**Re: ENVIRONMENTAL NOTIFICATION FORM: SUPPLEMENTAL INFORMATION, EEA No. 16514**

Proposed City of Boston Resilient Fort Point Channel Infrastructure Project  
Boston Planning & Development Agency  
Fort Point Channel Harborwalk between 15 Necco St. and Dorchester Ave.  
Boston, MA

**Figure 1.** General diagram of Segment 1 tie-in to existing grade contours and interim flood barrier at 11.5 ft NAVD88 (shown as 18 ft BCB), overlaid on excerpt from 15 Necco Street Grading and Drainage Plan dated January 8, 2021 and filed under DEP File No. 006-1490.

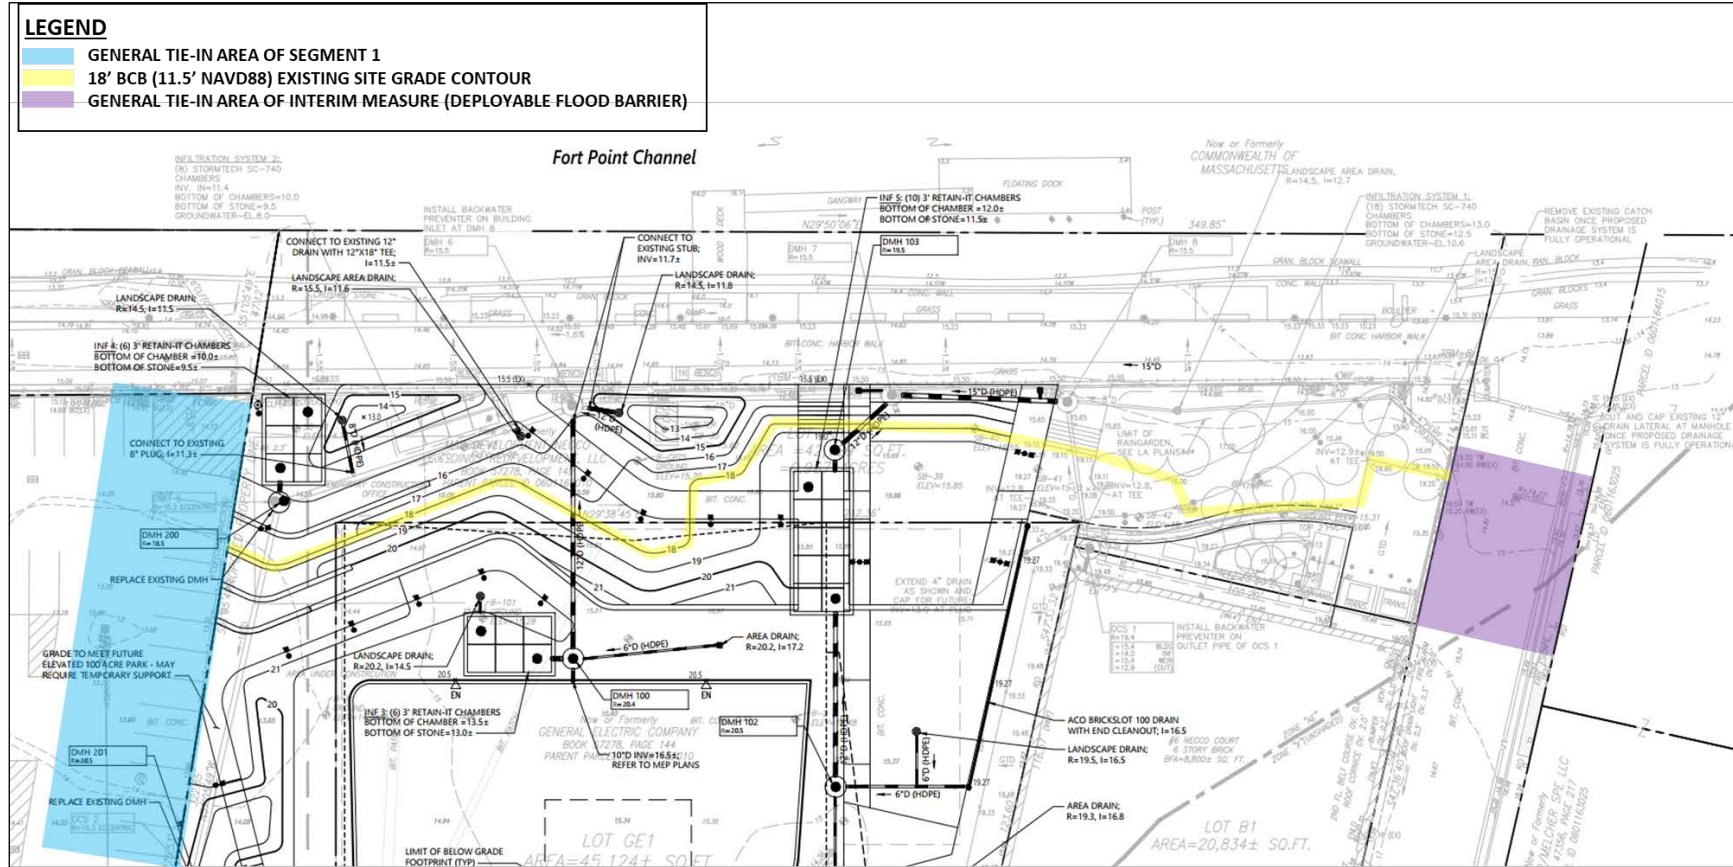
- (2) Buildings on solid foundations, slabs, and curbs and landscaping walls, fill, and other hard and impervious surfaces may have the effect of channeling flood waters, which increases the velocity of flow to adjacent areas. These obstructions to water flow may also deflect, reflect, or redirect wave energy, overwash, and flood waters onto adjacent resource areas, properties, and private and public roads.*

**The proposed project does not include the construction of any new buildings or the alteration of any existing buildings. The proposed project will construct permanent flood barriers, including the addition of fill, and interim flood barriers within LSCSF to create a continuous line of coastal flood protection set at consistent top elevations. The project will block a flow pathway across the lowest elevation portion of the east bank of the Fort Point Channel, tying into higher existing grades and structures at both the north and south ends of the project site. As depicted in Figure 1, the north end of Segment 1 will tie-in (blue area) to the elevated waterfront yard grade of the 15 Necco Street and 5 Necco Street sites, and an interim deployable flood barrier with a top elevation of 11.5 ft NAVD88 (18 ft Boston City Base) will be installed between the 5 Necco Street and 27 Melcher Street buildings to block the Necco Court flood pathway. At the south end, Segment 3 will tie-in to existing grades at 11.5 ft NAVD88 (green area), at Dorchester Ave (Figure 2). Only general tie-in areas are shown in Figures 1 and 2. The exact tie-in designs will be completed in future phases of design. As discussed in the ENF Application (pages 22-24), the proposed permanent flood barriers (Segments 1-3) have a design flood elevation (DFE) of 14.6 ft NAVD88, while the interim flood barriers have a DFE of 11.5 ft NAVD88. As sea level rises, funding is secured, and implementation capacity is built, additional actions are planned to adapt the proposed flood protection system to be independently effective up to elevation 14.6 ft NAVD88. No low elevation gaps will remain between Summer St and Dorchester Ave to concentrate velocities.**
